# INNER WEST COUNCIL

## DEVELOPMENT ASSESSMENT REPORT

<b>Application No.</b>	10.2016.44.5
<b>Address</b>	33 Smith Street, Summer Hill
<b>Proposal</b>	Modification of the approved residential development including change of unit mix, new winter gardens, additional affordable housing unit, internal and external reconfiguration and changes to landscaping
<b>Date of Lodgement</b>	24 August 2019
<b>Applicant</b>	Drummoyne Building Service Pty Ltd
<b>Owner</b>	Drummoyne Building Service Pty Ltd
<b>Number of Submissions</b>	12
<b>Value of works</b>	\$3,681,938.00
<b>Reason for determination at Planning Panel</b>	Number of submissions exceeds officer delegation Apartment Design Guide (ADG) applies
<b>Main Issues</b>	Building height, internal layout, waste management and storage
<b>Recommendation</b>	Approved with Conditions
<b>Attachment A</b>	Recommended modified conditions of consent
<b>Attachment B</b>	Plans of proposed development

**BASEMENT PLAN**  
1:200

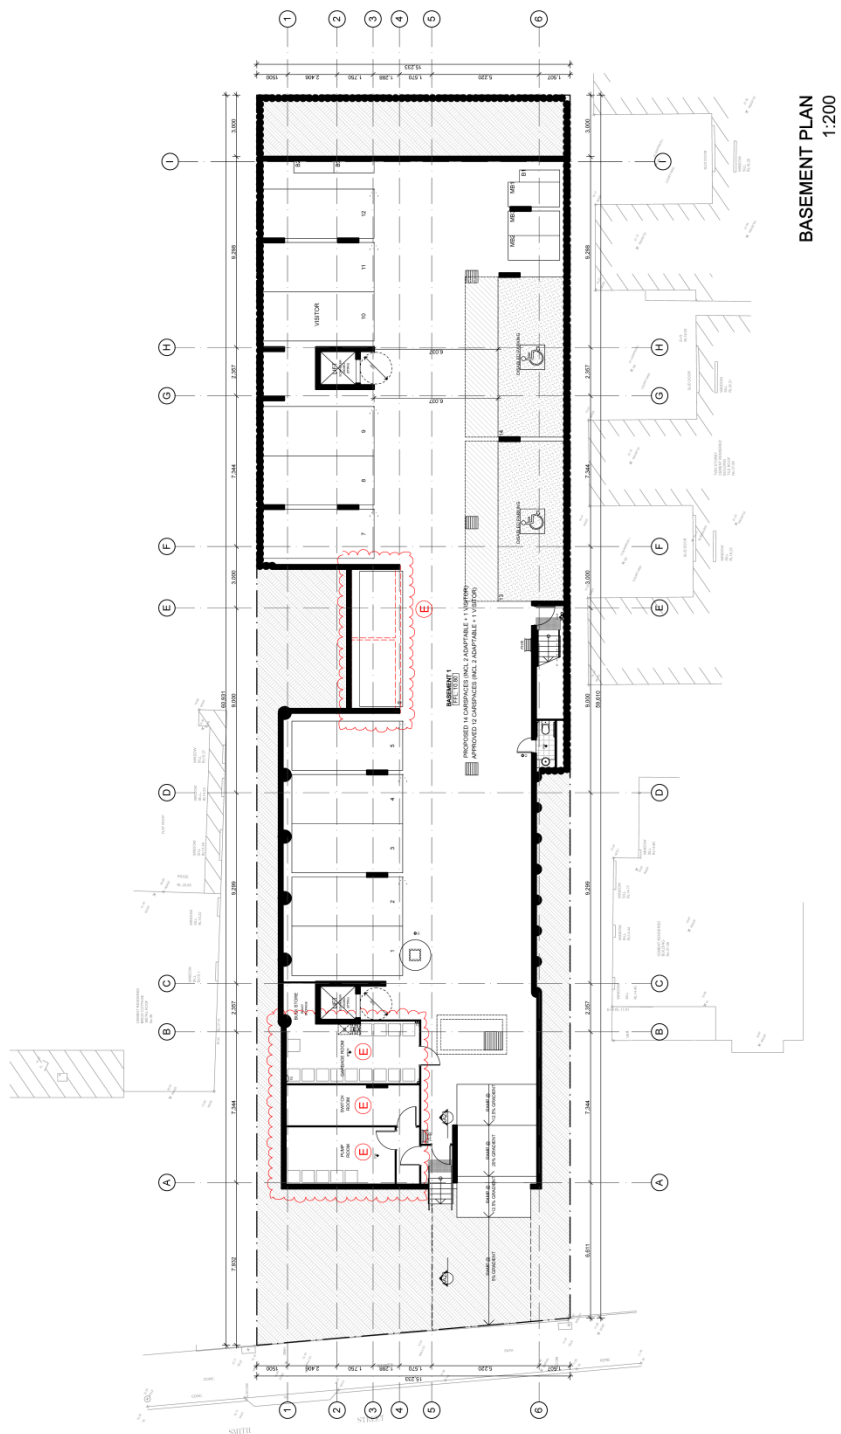
The proposed modifications to layout of the basement level has resulted in a bulky waste room that does not satisfy the minimum size dimension required by Section 2, Chapter C, Part 3 of the CIWDCP 2016. As such, a condition of consent has been imposed which requires the basement be amended to provide a bulk waste storage area with a minimum area of 4sqm. In addition, a condition of consent has been imposed which requires nine (9) 240L garbage bins and nine (9) 240 recycling bins be provided on the site, in accordance with the requirements of Section 2, Chapter C, Part 3 of the CIWDCP 2016.

- a) The bulk waste storage area be amended to have a minimum area of 4sqm;
- b) The garbage room be amended to provide nine (9) 240L garbage bins and nine (9) recycling bins;

ROOF & MEZZANINE PLAN  
1:200

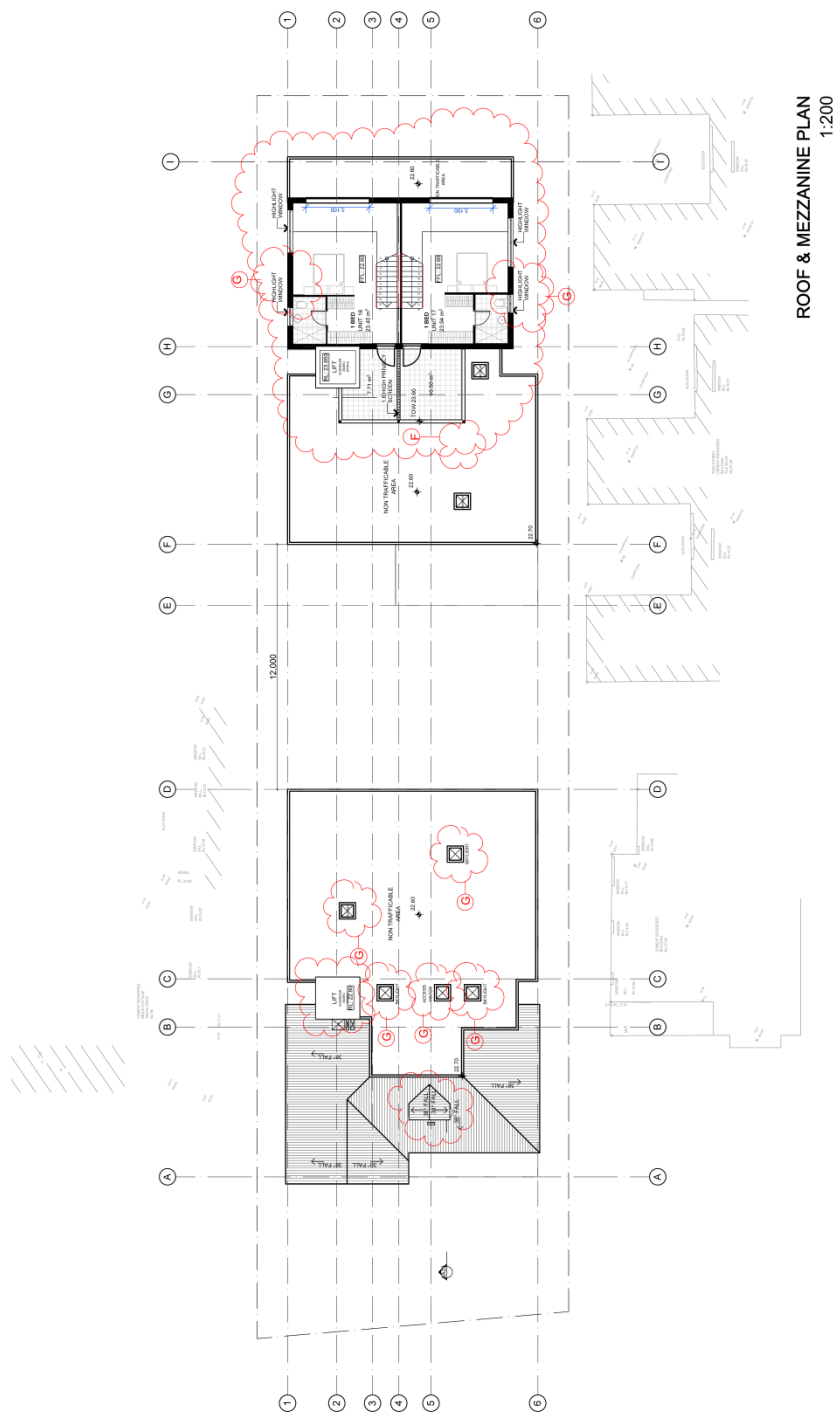
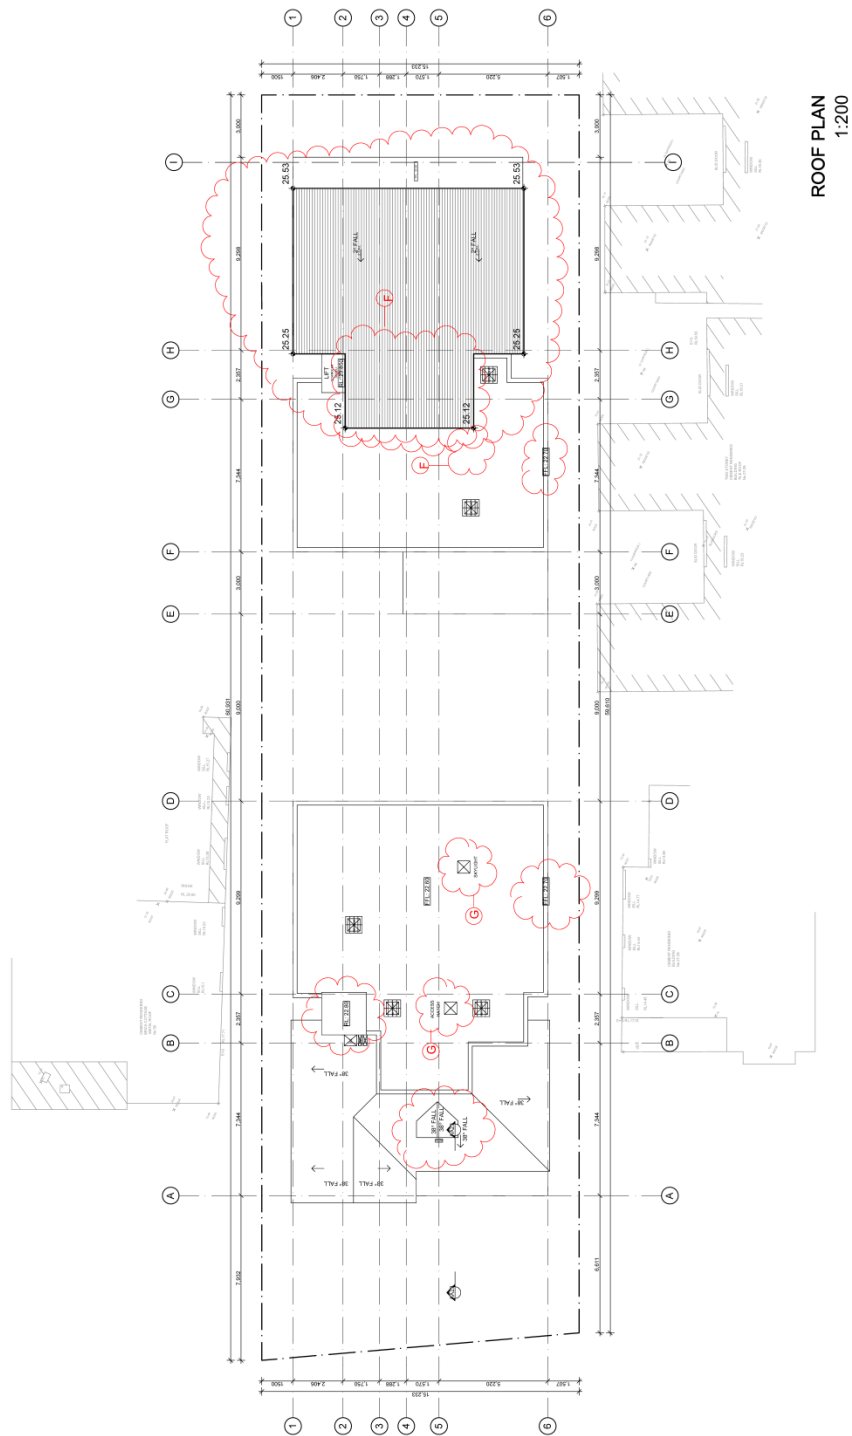
- The proposed modifications to Units 16 and 17, including the rooftop terrace area exceed the maximum height permitted on the site and an accurate assessment of the overshadowing impact could not be undertaken;
- The proposed modifications to Units 16 and 17 resulted in living spaces of minimal size and insufficient information was provided to provide an accurate assessment of the storage provided in the units; and
- The proposed modifications reduced the number of bins provided on the site and reduced the size of the bulky waste storage area.

- Addition of a dormer window on the front elevation;
- Addition of a master bedroom for Units 16 and 17 which exceed the maximum height permitted by approximately 1.1m including south facing terraces being 8sqm and 11sqm in size;
- Addition of roofs over the terraces which exceed the maximum height permitted by 1.25m;
- Increase to the height of the existing roofs and lift overruns by between 100mm to 200mm;

The applicant seeks a variation to the Height of Building development standard under Clause 4.3 of the applicable local environmental plan by 13.8% (1.25 metres).

Comment: The proposed additional building height is limited to the rear of the development with minimal floor to ceiling heights and maintains the existing building setbacks. It is not considered that the additional 1.25m of height will result in any unreasonable visual bulk and scale impacts or view loss. In addition, the roof extension will largely not be visible from the street and will not impact the adjacent heritage conservation areas.
